**City of Bellevue
Development Services Department
Land Use Staff Report**

Proposal Name: Chen Residence Steep Slope Buffer Critical Area Modification

Proposal Description: Critical Areas Land Use Permit for the modification of a steep slope critical area buffer to construct a new single-family residence. The proposal is supported by a Critical Areas Report and includes native vegetation planting as mitigation.

File Number: 19-109537-LO

BUFFER REDUCTION/RESTORATION PLAN

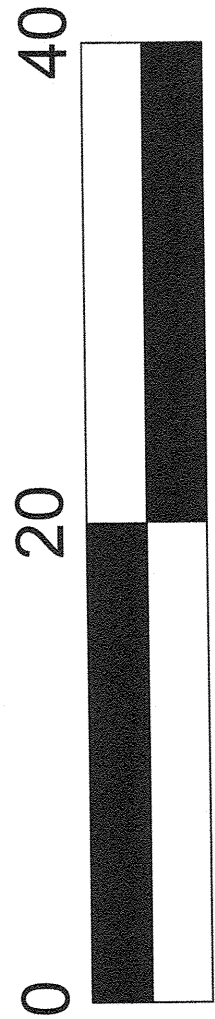
Revisions	Comment
1 July 2019	Added restoration plan

- 3. Mitigation Plan:** Consistent with the plan the applicant must include the mitigation planting plan (Attachment 2) as part of the building permit.
